Form C-103
 Revised July 18, 2013

<p>SUNDRY NOTICES AND REPORTS ON WELLS (DO NOT USE THIS FORM FOR PROPOSALS TO DRILL OR TO DEEPEN OR PLUG BACK TO A DIFFERENT RESERVOIR. USE "APPLICATION FOR PERMIT" (FORM C-101) FOR SUCH PROPOSALS.)</p> <p>1. Type of Well: Oil Well <input checked="" type="checkbox"/> Gas Well <input type="checkbox"/> Other</p> <p>2. Name of Operator Sandlott Energy (Jackie Brewer DBA)</p> <p>3. Address of Operator P.O. Box 711 Lovington, NM 88260</p> <p>4. Well Location Unit Letter <u>C</u> : <u>1060</u> feet from the <u>North</u> line and <u>2380</u> feet from the <u>West</u> line Section <u>32</u> Township <u>18S</u> Range <u>28E</u> NMPM <u>Eddy</u> County</p>		WELL API NO. 30-015-02146

Plug and Abandon

Wellname: RESLER YATES #61

Vertical schematic (actual)

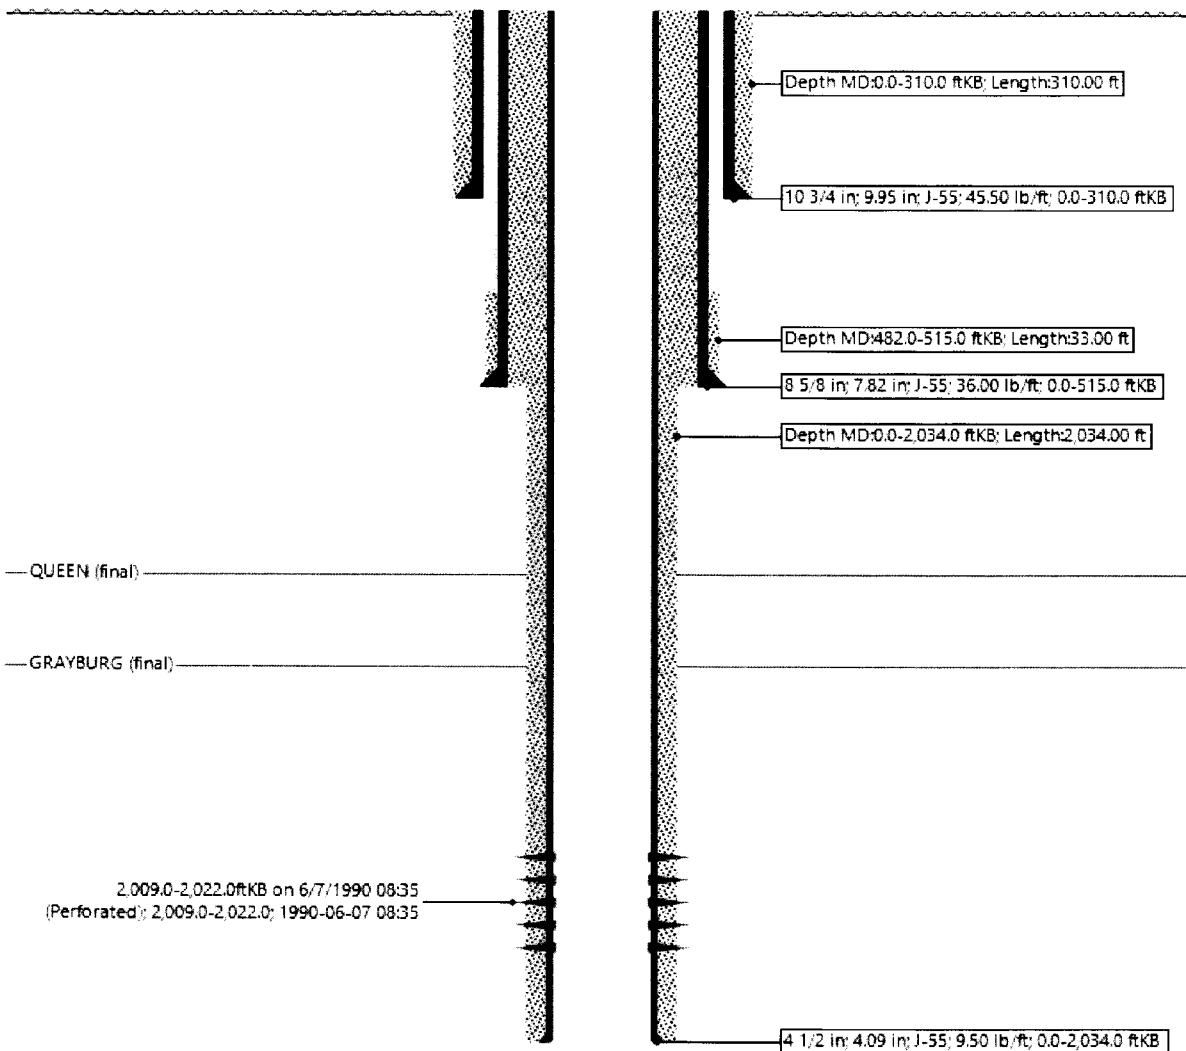
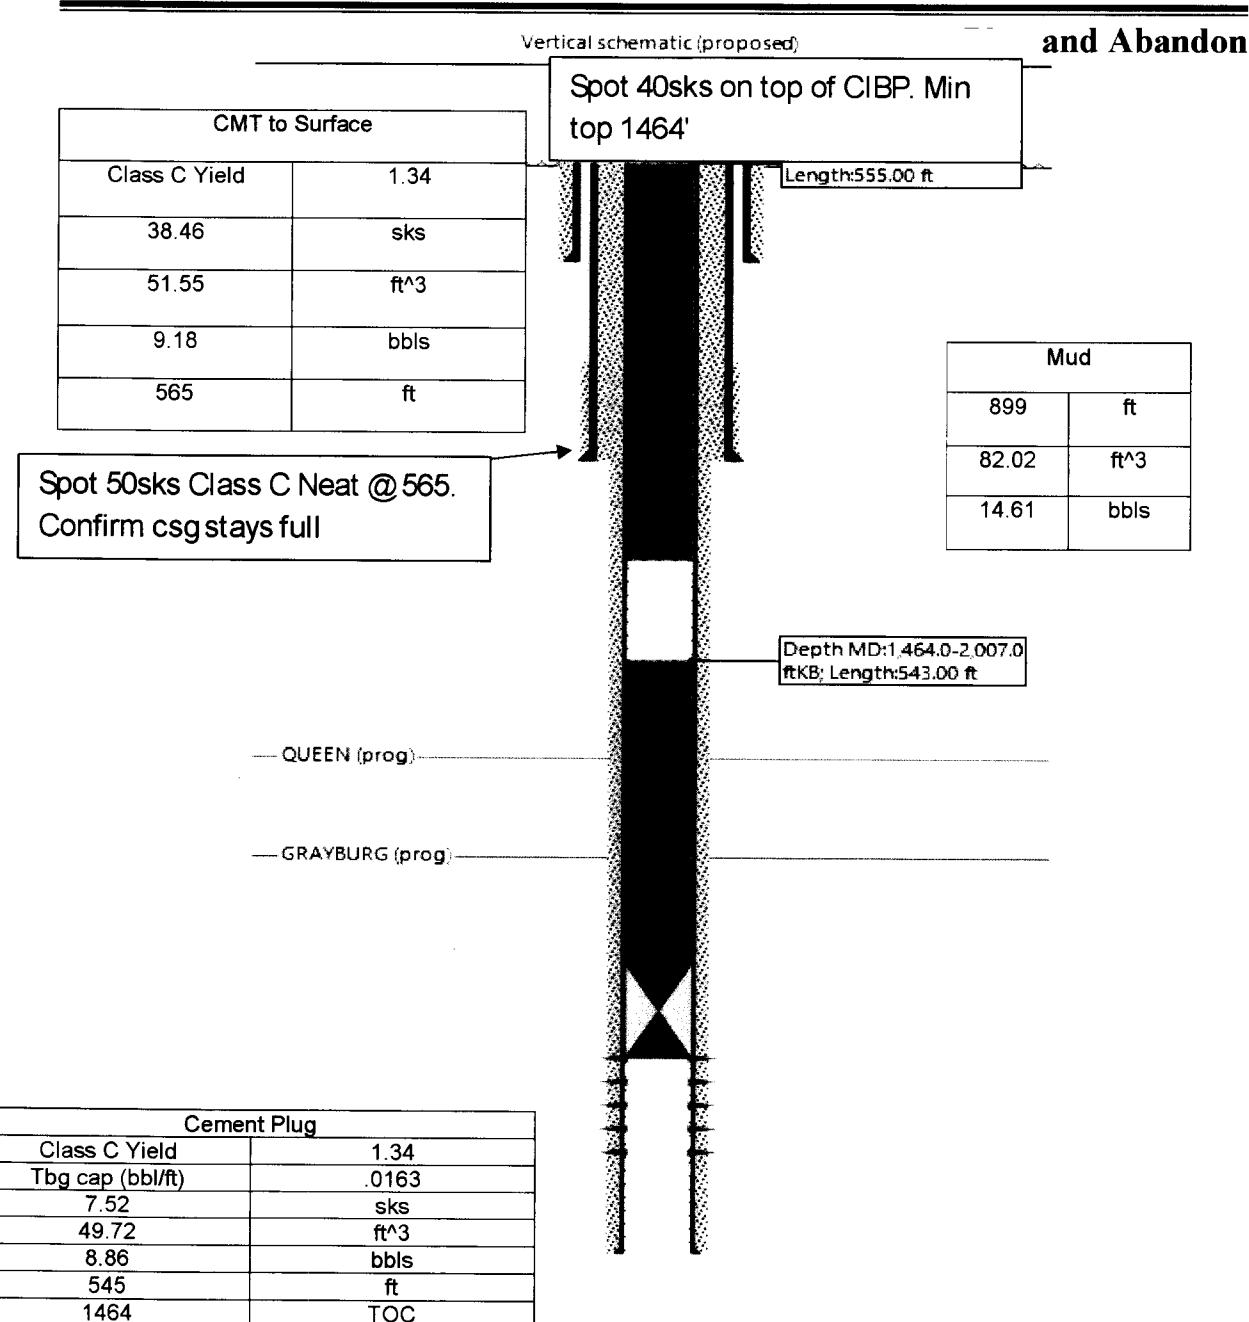
Created By	Condition	Condition Date
loren.diede	Notify the OCD inspection supervisor via email 24 hours prior to beginning Plug & Abandon (P&A) operations.	11/13/2025
loren.diede	NMOCD does not consider this well to be within the LPCH restricted area and an above ground P&A marker is required. NMOCD requires that plug(s) be added to cover the 7 Rivers = (970') and Yates = (560') formation tops. Submit photo and GPS coordinates of the P&A marker with the final P&A reports. The API# on the marker is to be clearly legible. Run CBL from CIBP to surface. Submit the CBL tif file to NMOCD for uploading into the Well Log File.	11/13/2025
